MODEL BD-100-1A10 (CH-350)

ATA 76-00

**MODIFICATION - ENGINE CONTROLS -  
ADDITION OF RELAYS TO THROTTLE QUADRANT ASSEMBLY (TQA) TO PREVENT  
SPOILER ELECTRONIC CONTROL UNIT (SECU) NUISANCE MESSAGES**

TQA Relays Installation  
 Figure 1

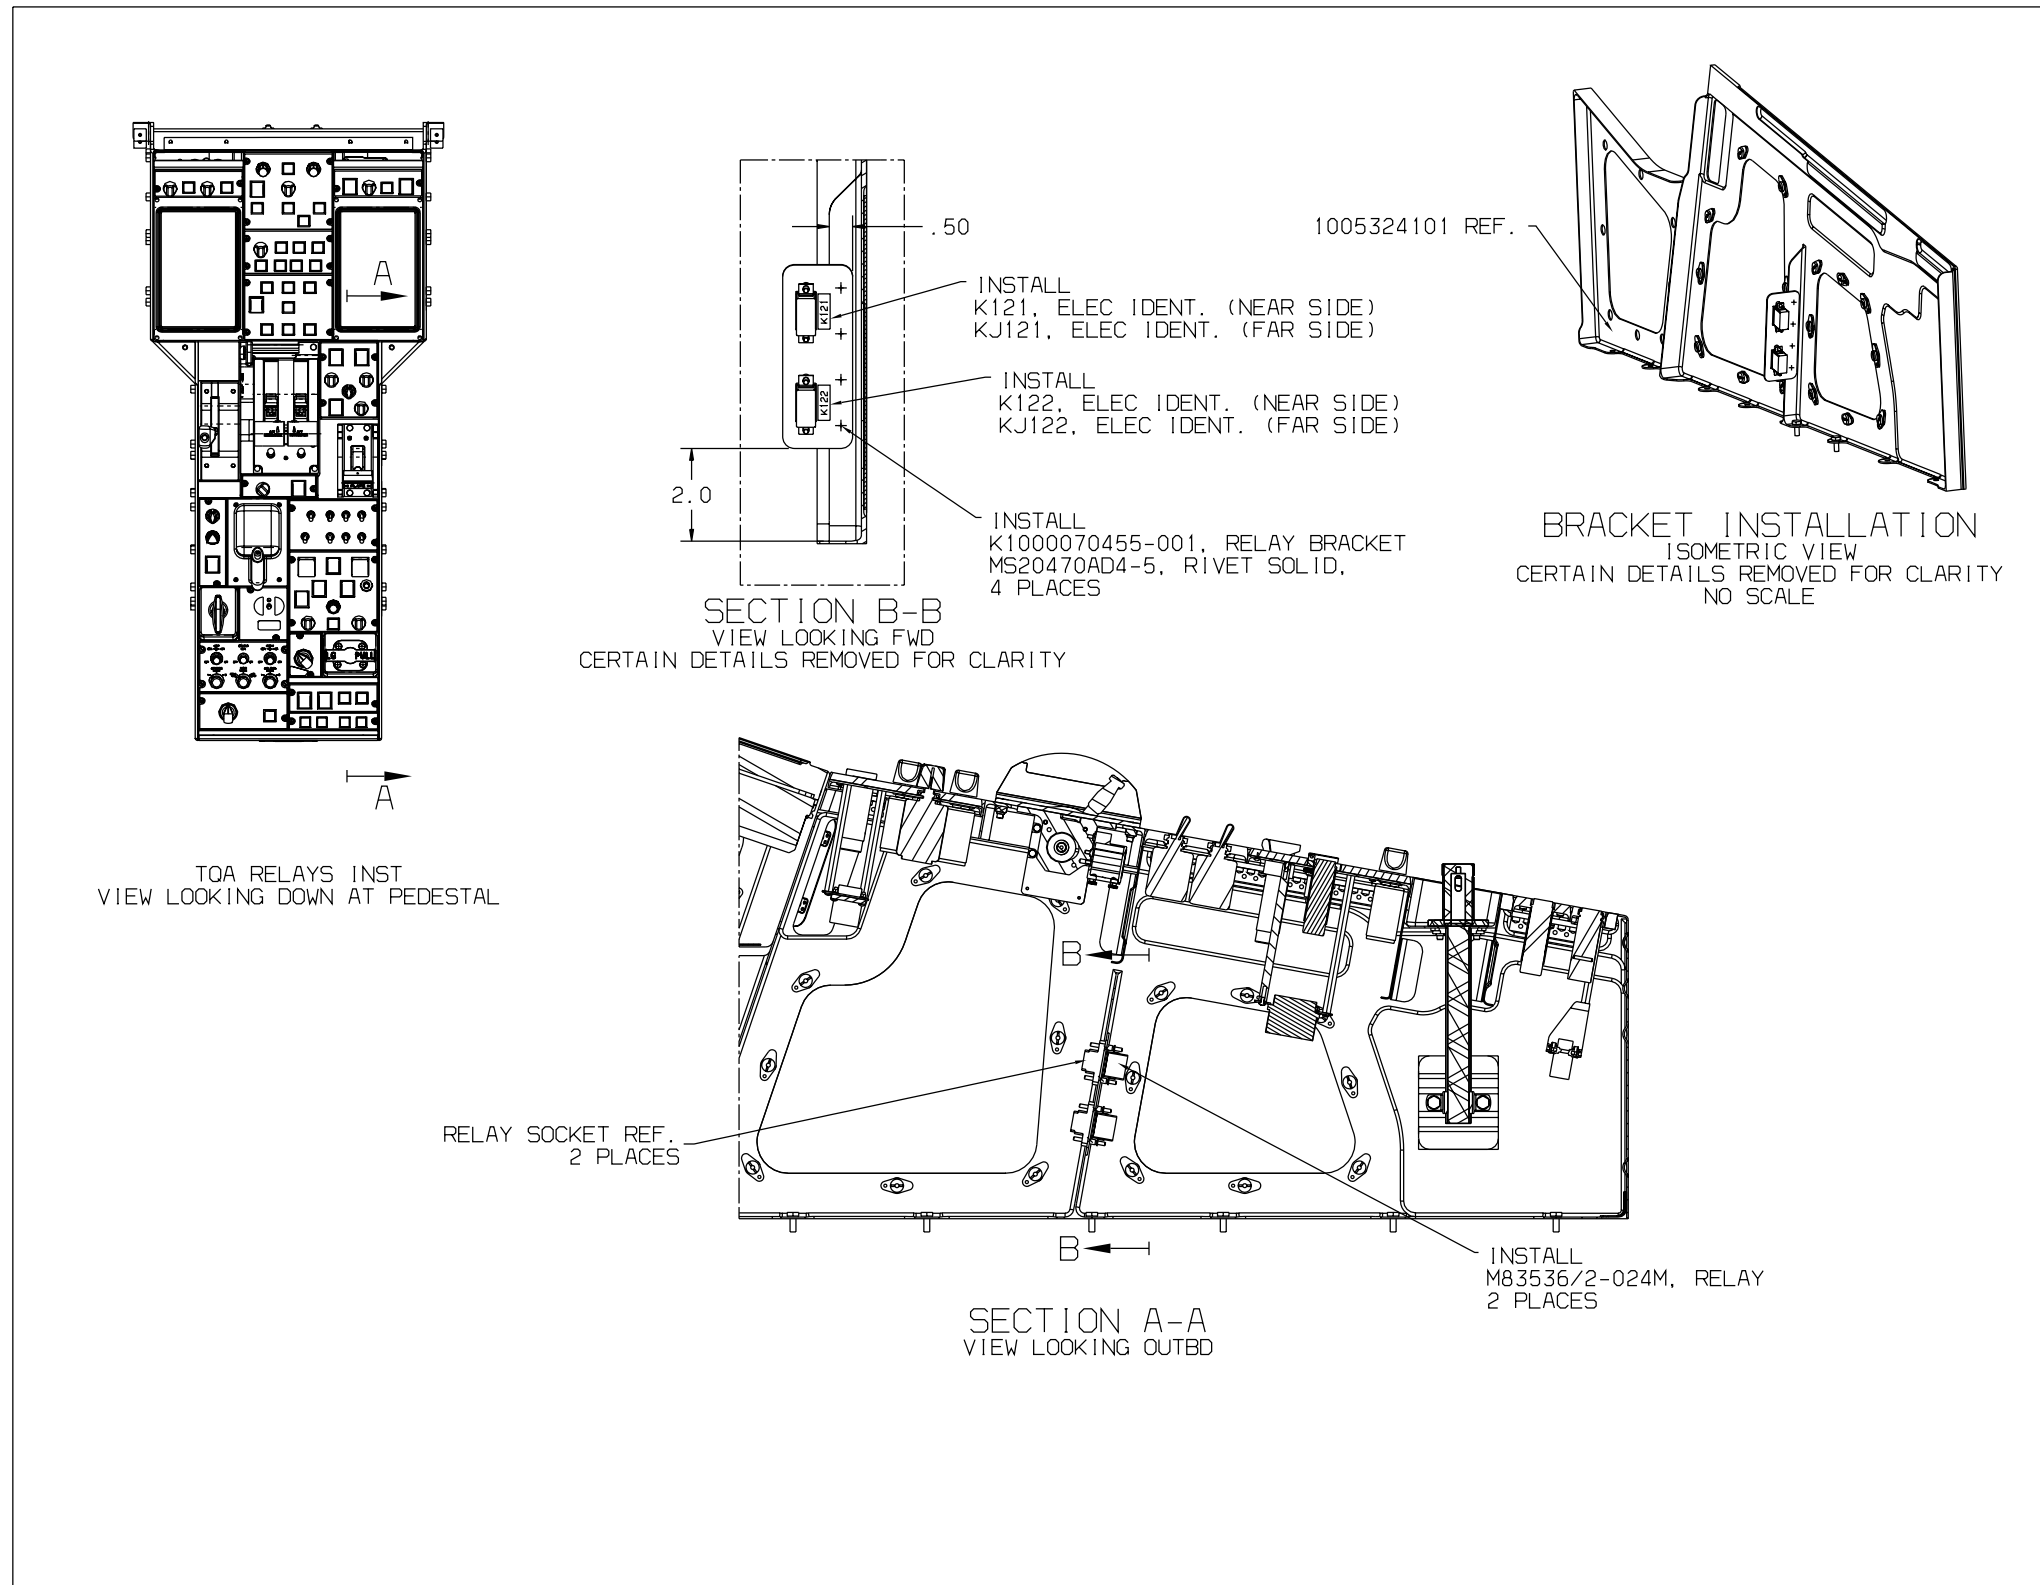
- (2) Obey all electrostatic discharge safety precautions. Refer to AMM 24-00-00-910-802.
- (3) Install the bracket, Part No. K1000070455-001, with rivets MS20470AD4-5 per SRM 51-42-08. Refer to Figure 1.
- (4) Install the relay sockets M12883/45-01 and relays M83536/2-024M. Refer to SPM 20-39-00-02.
- (5) Touch-up the reworked areas on aluminum parts per finish code X060. Refer to SRM 51-01-04.
- (6) Faying surface seal per SPM 51-23-00.
- (7) Do the identification (ink stamp) per best shop practices.
- (8) Do the wiring modification. Refer to Figure 2 and 3.
  - (a) Relocate the wires as follows.

Wiring modification  
Figure 3

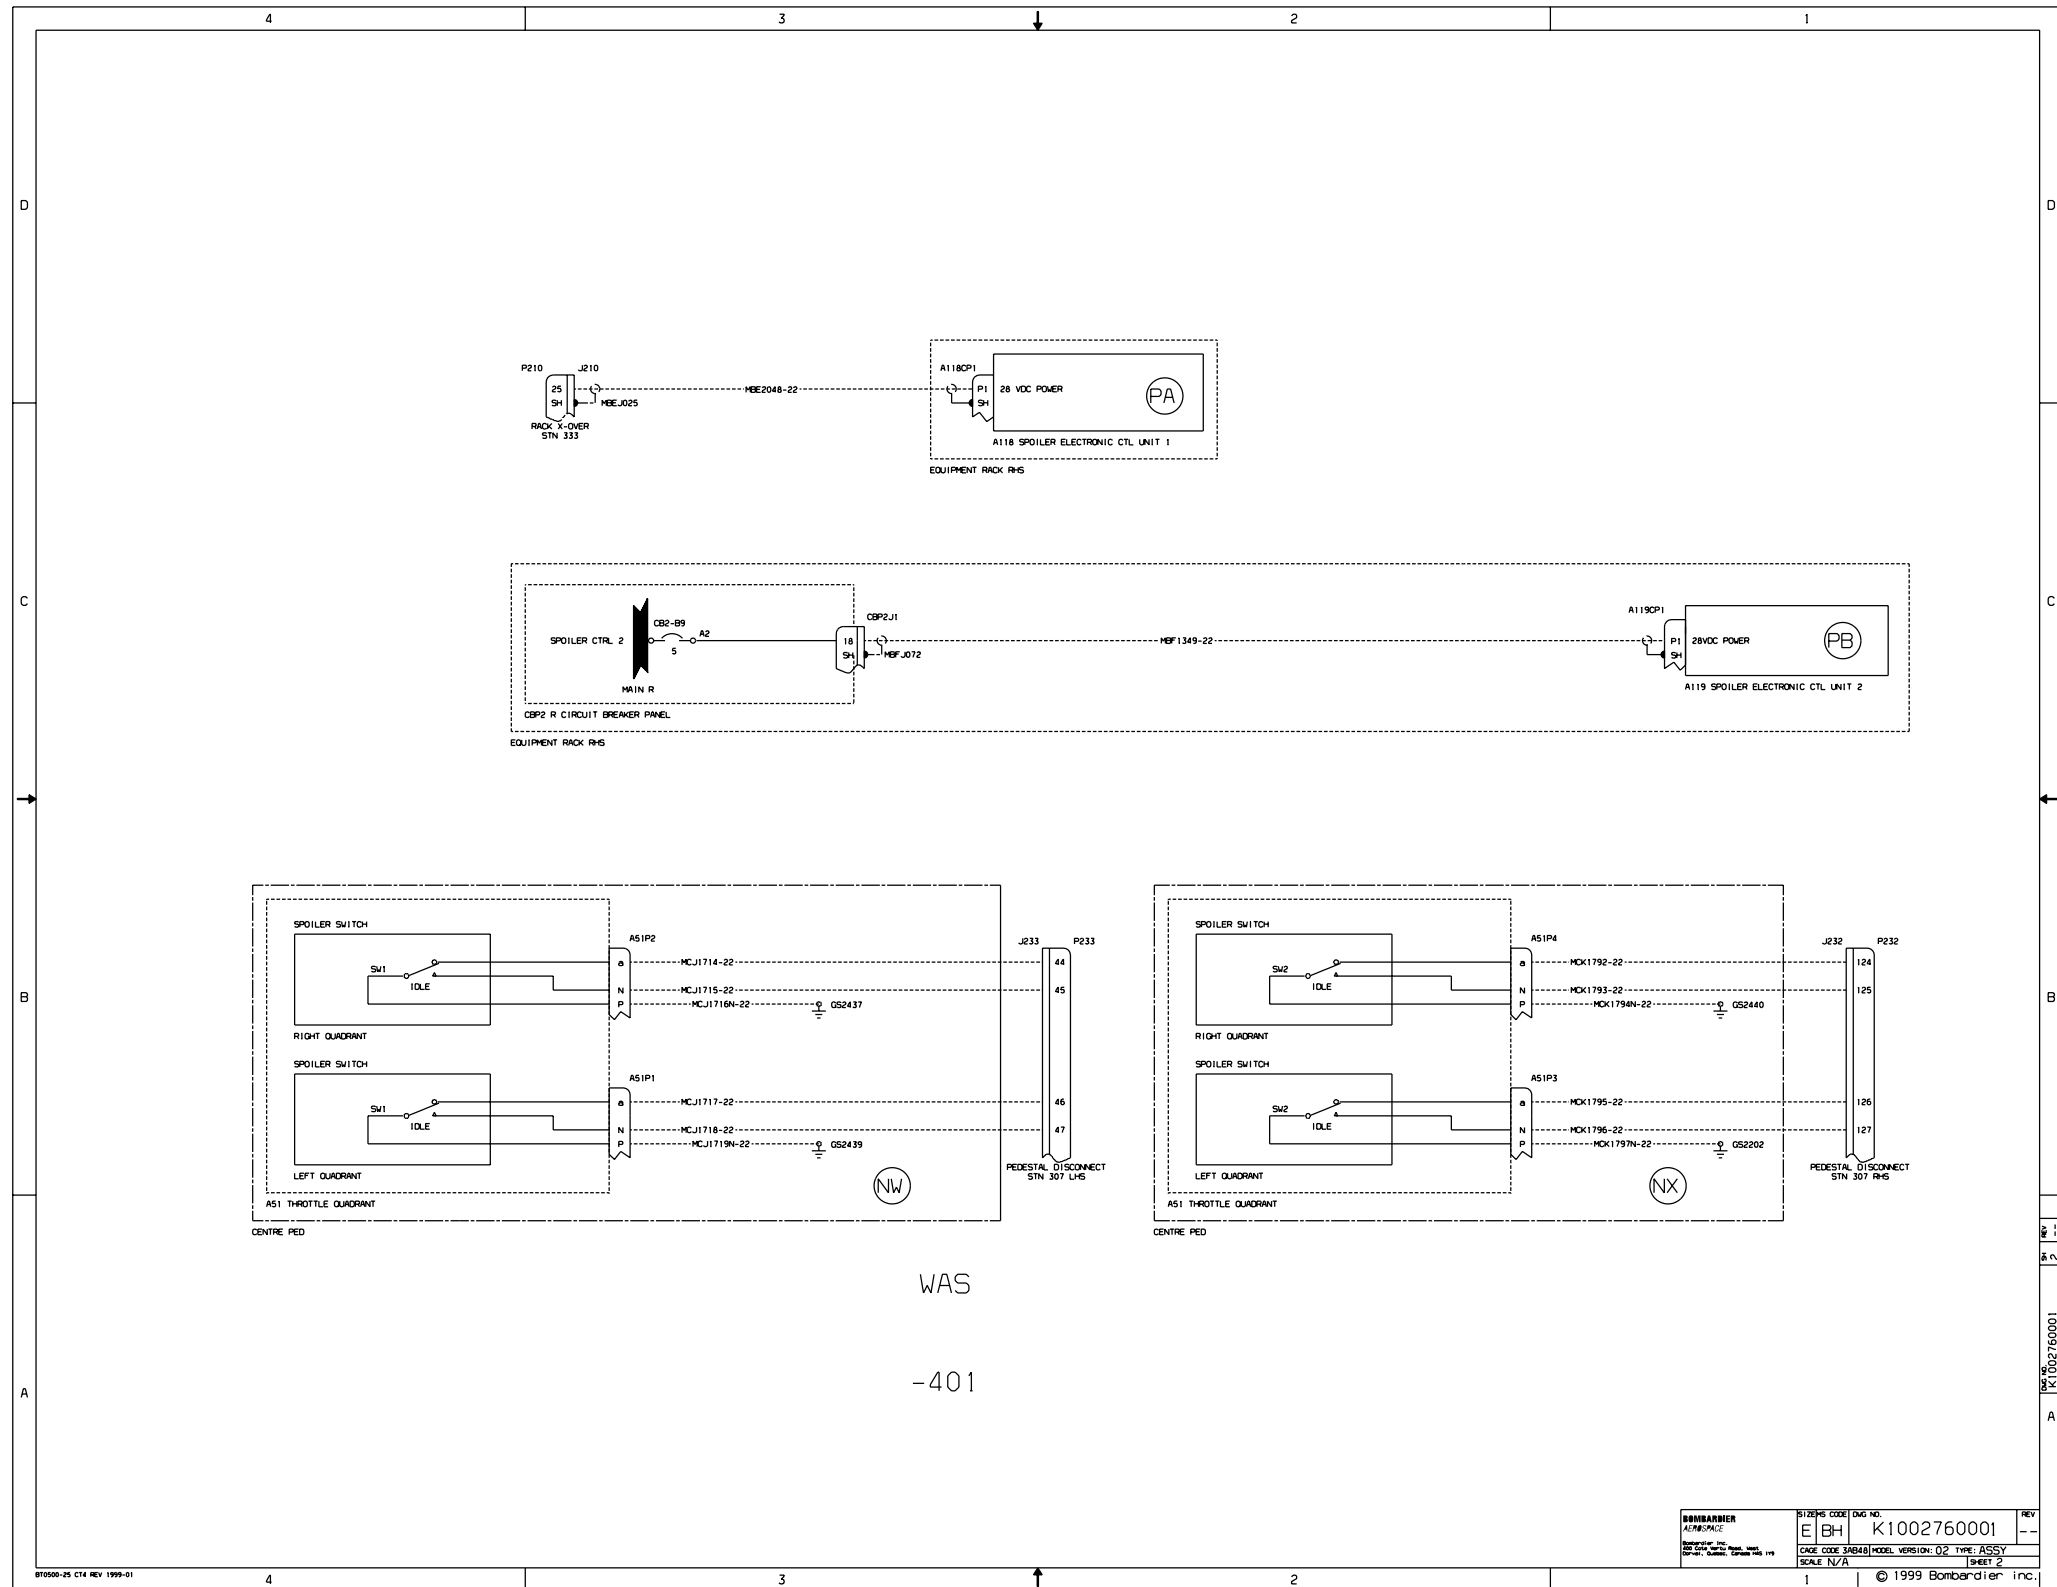
(b) Install the wires as follows.

NUMBER	TYPE	FROM (IS)		TO (IS)	
		IDENT	PIN	IDENT	PIN
MBE2048	B0801690-22	A118CP1	P1	SP145	2
MBF1349	B0801690-22	A119CP1	P1	SP146	2
MCJ1714	B0801190-22-9	J233	A4	KJ122	B3
MCJ1715	B0801190-22-9	J233	A5	KJ122	B1
MCK1792	B0801190-22-9	J232	124	KJ122	A3
MCK1793	B0801190-22-9	J232	125	KJ122	A1
MCK1795	B0801190-22-9	J232	126	KJ121	B3
MCK1796	B0801190-22-9	J232	127	KJ121	B1
MCJ1717	B0801190-22-9	J233	46	KJ121	A3
MCJ1718	B0801190-22-9	J233	47	KJ121	A1
MCK1797N	B0801190-22-9	GS2202	GND	A51P2	P
MCJ1716N	B0801190-22-9	GS2437	GND	A51P3	P

(c) Install new wires as follows.

NUMBER	TYPE	FROM		TO	
		IDENT	PIN	IDENT	PIN
MBE2811	B0801690-22	J210	25	SP145	1
MBE2731	B0801690-22	SP145	2	P232	25
MBEJ026	SUPPLIED TAIL	P232	SHD	P232	SHD
MCE2731	B0801190-22-9	J232	25	KJ121	X1
MBF2734	B0801690-22	CBP2J1	18	SP146	1
MBF2733	B0801690-22	SP146	2	P232	26
MBFJ073	SUPPLIED TAIL	P232	SHD	P232	SHD
MCF2733	B0801190-22-9	J232	26	KJ122	X1
MCKJ043	B0801190-22-9	A51P2	N	SP144	1
MCK2745	B0801190-22-9	A51P4	N	SP144	2
MCJ2741	B0801190-22-9	A51P1	N	SP143	1
MCJJ025	B0801190-22-9	A51P3	N	SP143	2
MCJ2742N	B0801190-22-9	KJ122	B2	GS2435	GND
MCK2744N	B0801190-22-9	KJ122	A2	GS2436	GND
MCK2735	B0801190-22-9	KJ122	X2	SP144	2
MCK2747N	B0801190-22-9	KJ121	B2	GS2438	GND
MCJ2748N	B0801190-22-9	KJ121	A2	GS2437	GND
MCJ2746	B0801190-22-9	KJ121	X2	SP143	2
MBEJ029	SUPPLIED TAIL	J210	SHD	J210	SH
MBFJ083	SUPPLIED TAIL	CBP2J1	SHD	CBP2J1	SH
